**Project No. V025-13807**
**ADDENDUM NO. 3**
**Rawson Avenue Storm Water Lift Station**
**700 West Rawson Avenue, Oak Creek, WI**

**Project No.: V025-13807**
**Date of Addendum: 10/2/13**

This Addendum to the Contract Documents is issued to modify, explain, or correct the original documents, dated 9/13/13, and is hereby made part of the Contract Documents. Acknowledge receipt of this Addendum in the space provided on the Bid Form, or bid may be rejected.

EXCAVATION LIMITS

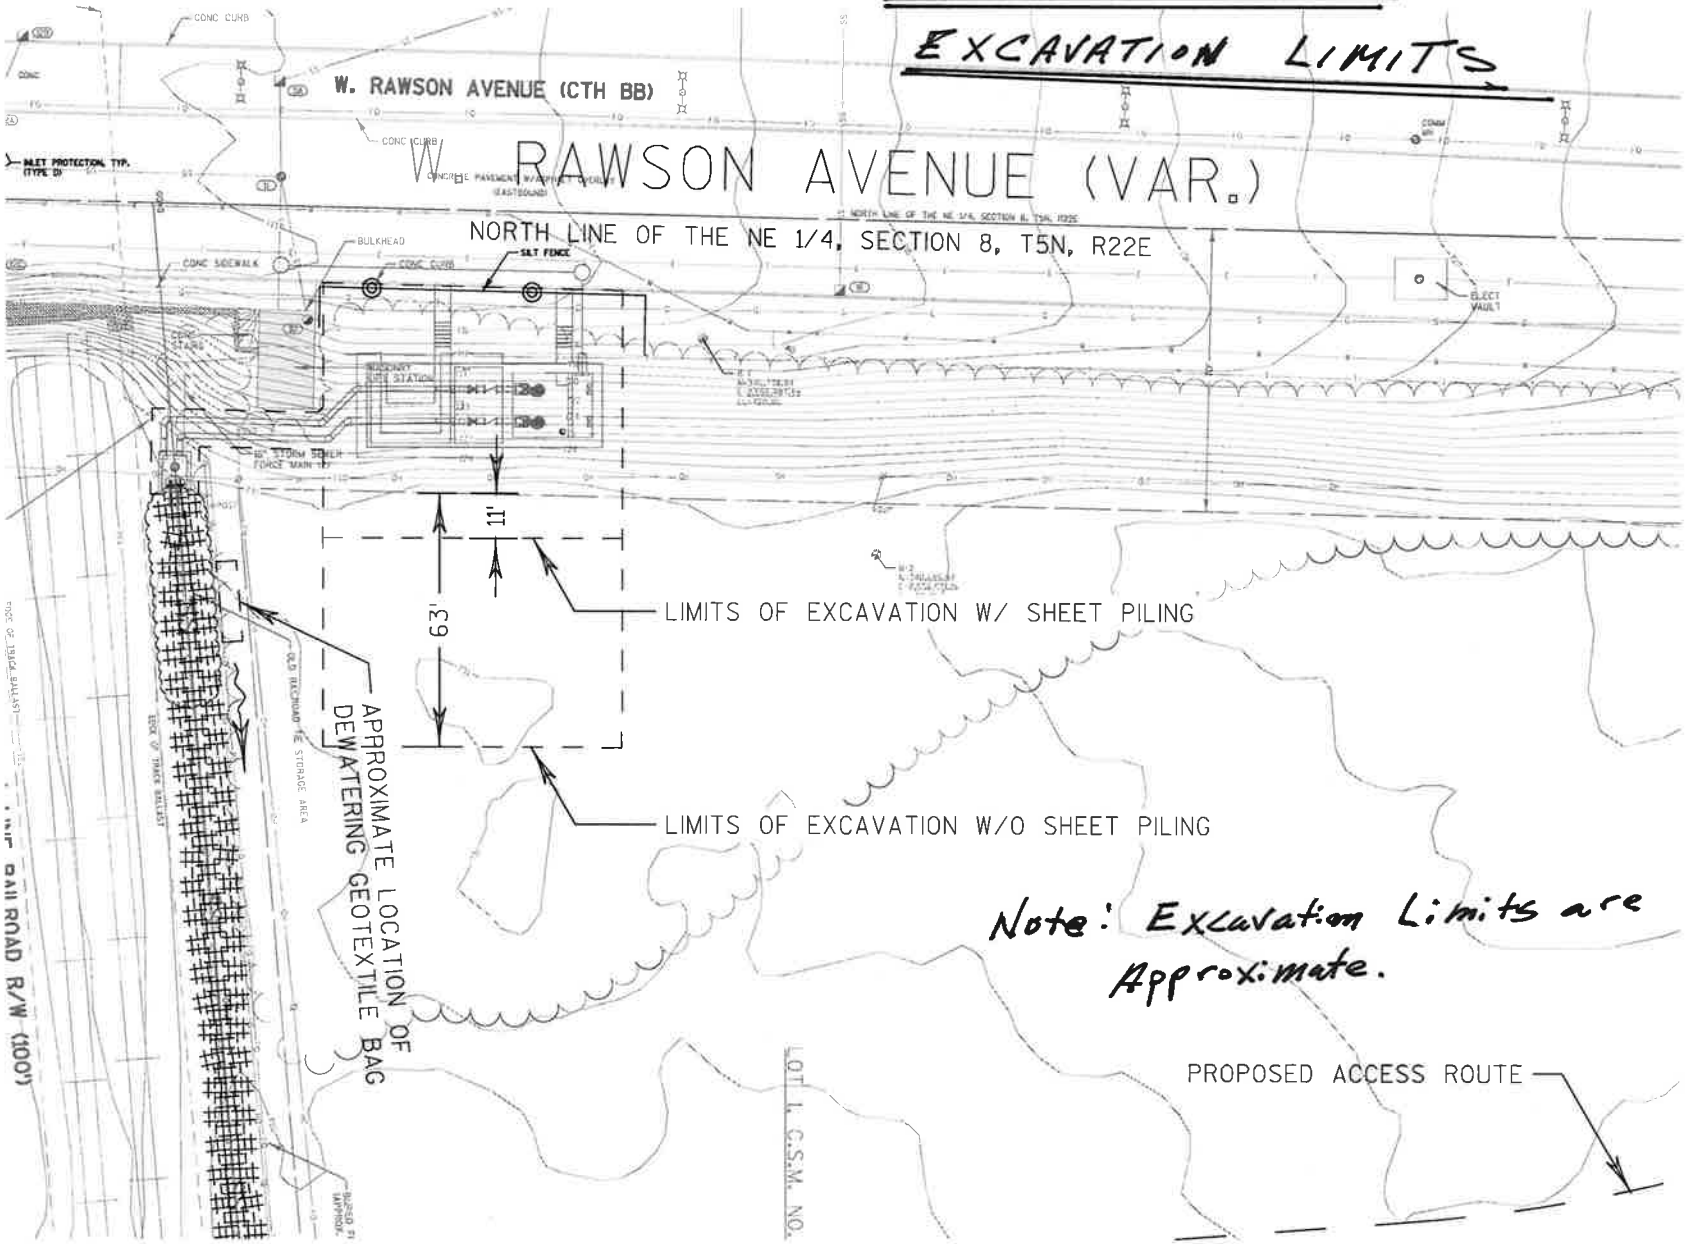
Add 2: Add the following to Article 1.06: "H. Excavation of embankment is allowable to construct lift station and thereby avoid or minimize need for sheet piling on south side of structure. CONTRACTOR is responsible for backfilling and restoring excavation to original grades. Seed and mulch as part of restoration. Maintain appropriate distance from power poles and wires to comply with We Energies requirements. Refer to Attachment C for a sketch showing approximate excavation limits of south side of lift station."

**STORM WATER LIFT STATION CIVIL SITE PLAN**

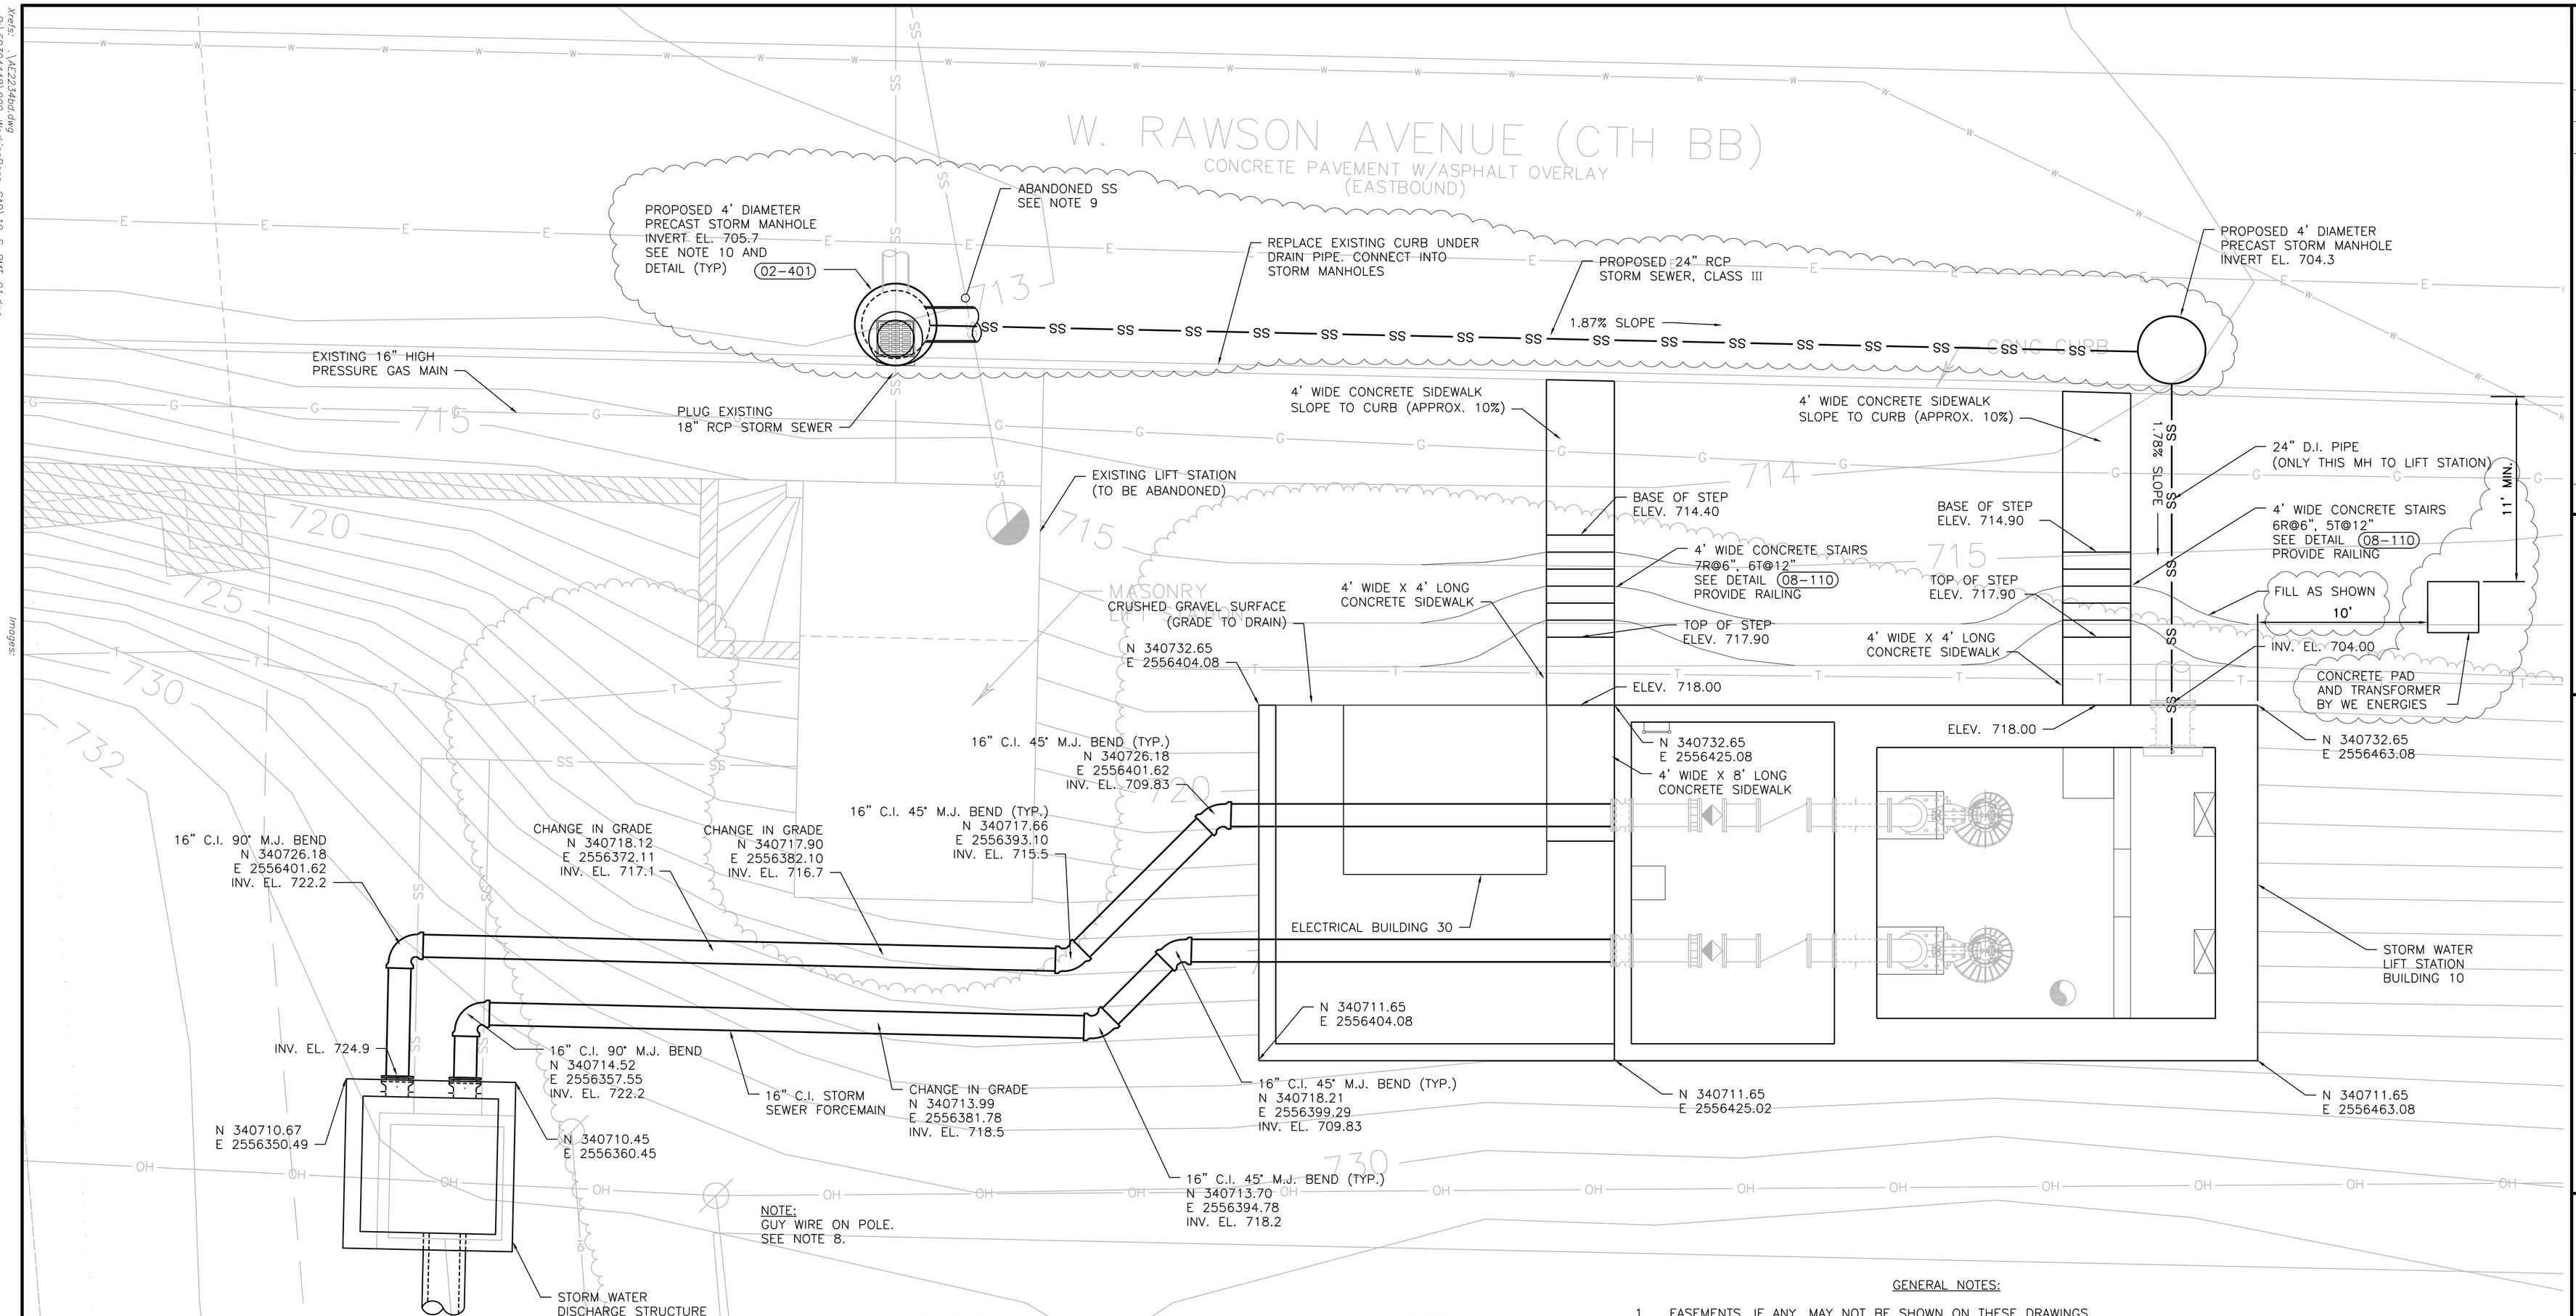
Delete Drawing No. 02-C-05 in its entirety and replace with the attached revised Drawing 02-C-05. The revisions relate to the proposed storm sewer location, and shows the proposed location for transformer pad.

**MANHOLE TYPE A** (02-401)
NTS

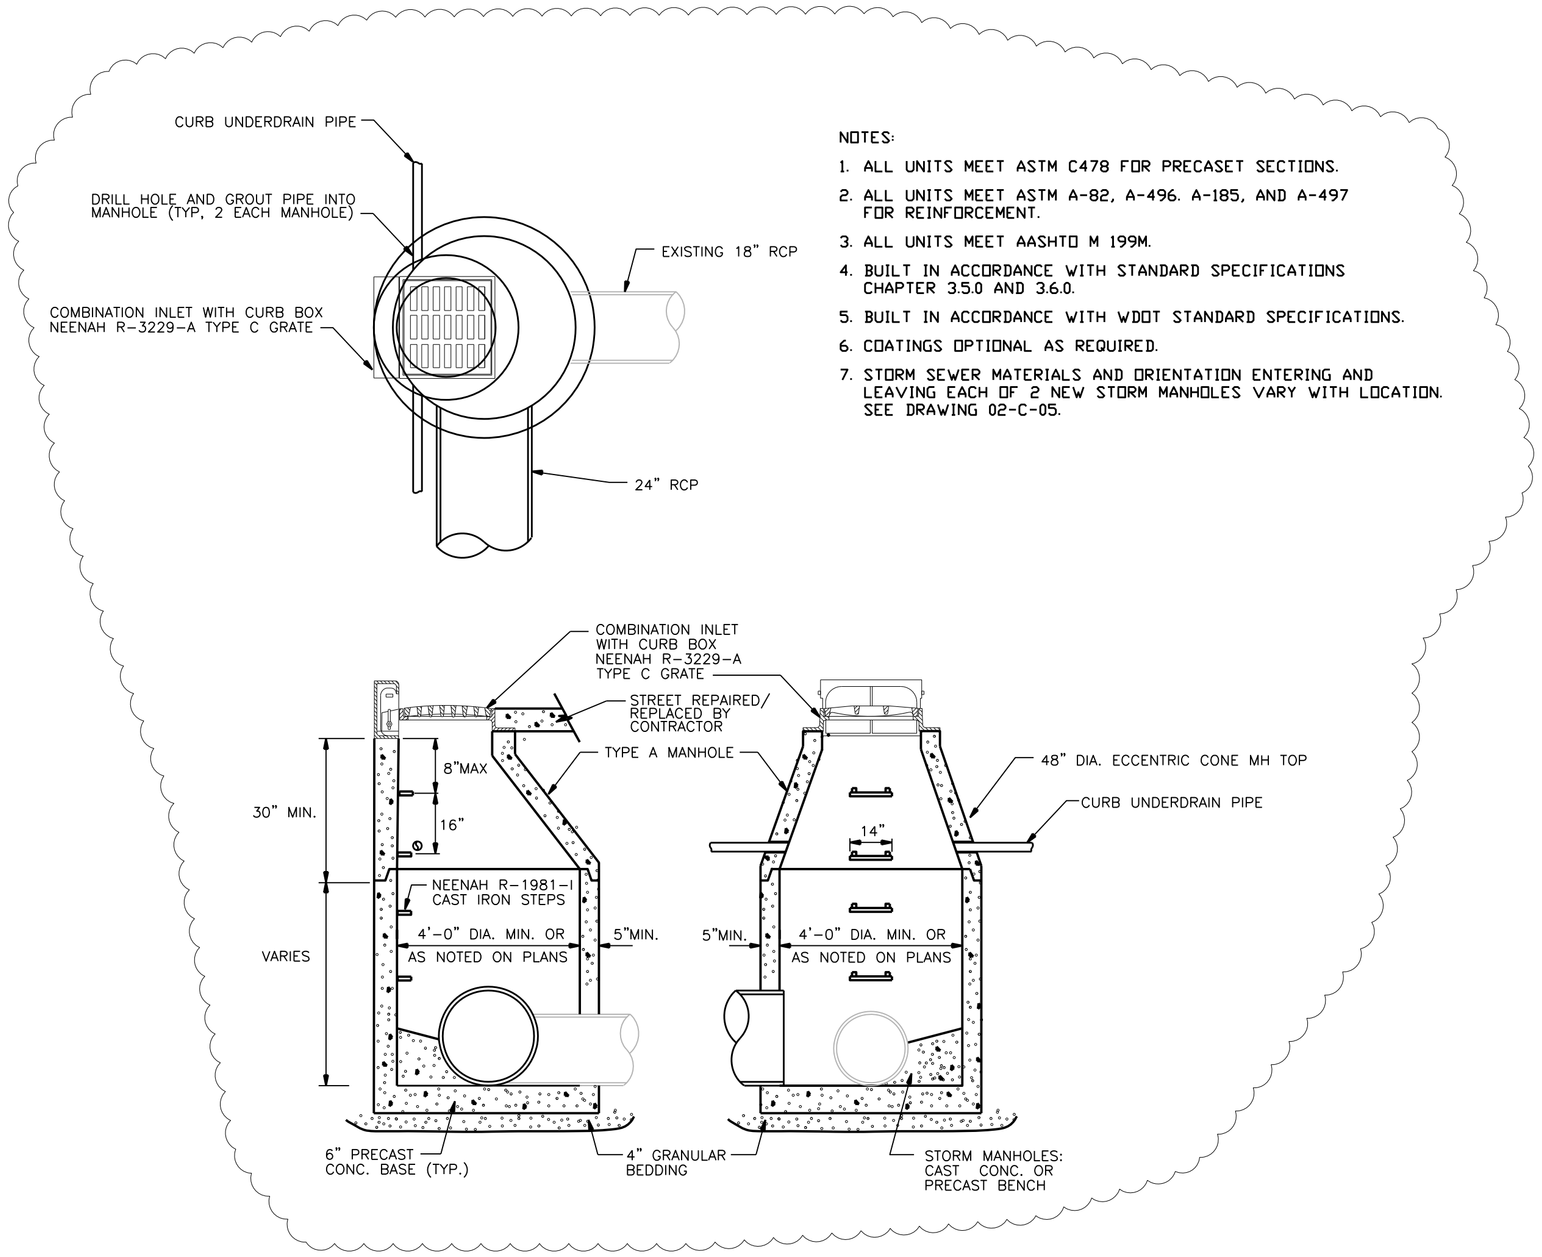
Delete Detail 02-401 on Drawing 99-C-01 and replace with the attached Detail 02-401.

**STORM WATER PUMP STATION LOWER PLAN**

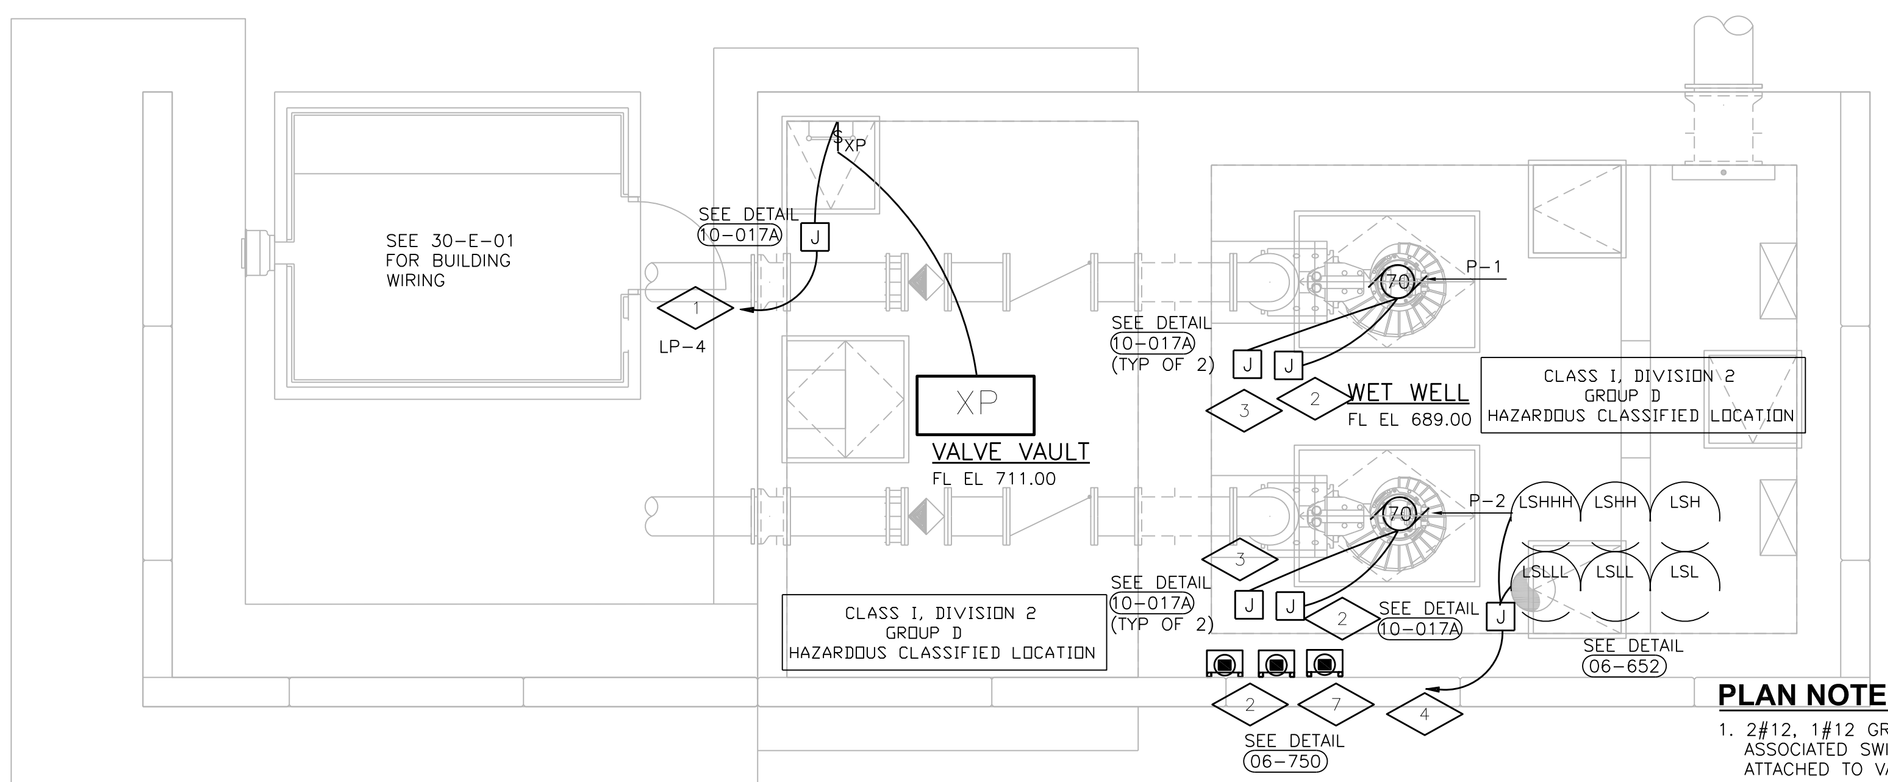
Add approximate location of utility supplied transformer pad.

APPROXIMATE LOCATION OF UTILITY SUPPLIED TRANSFORMER AND PAD. ROUTE 4" PVC COATED CONDUIT PER DETAIL (10-262) TO 400A CONTRACTOR SUPPLIED UTILITY APPROVED TRANS SOCKET LOCATED ON NORTH SIDE OF ELECTRIC BUILDING. REFER TO 02-C-05 FOR LOCATION.

**ELECTRICAL BUILDING POWER AND LIGHTING PLAN**

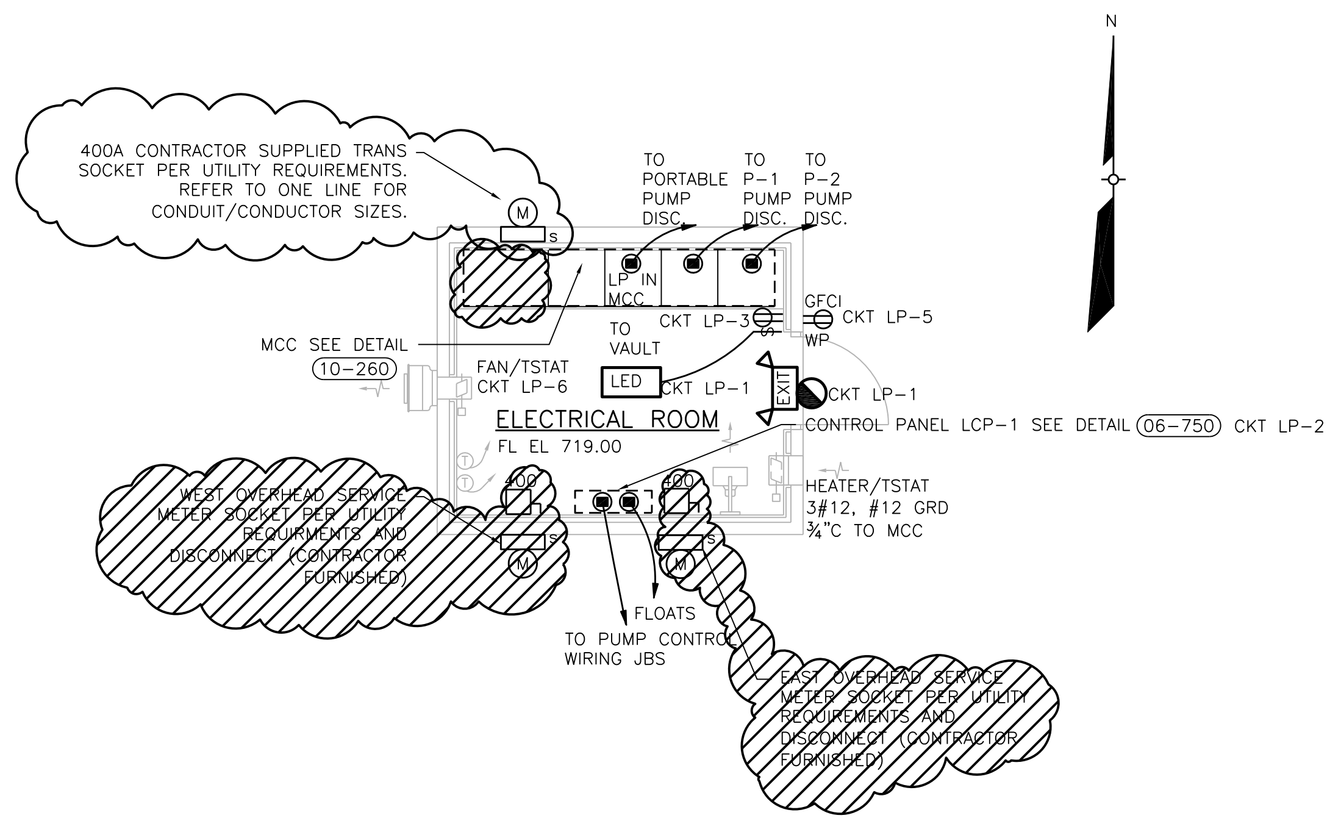
Two meter sockets, two 400-amp disconnects, and transfer switch portion of MCC to be removed from design. New 400-amp trans socket may be placed on north side of building for ease of underground concrete encased conduit to transformer pad.
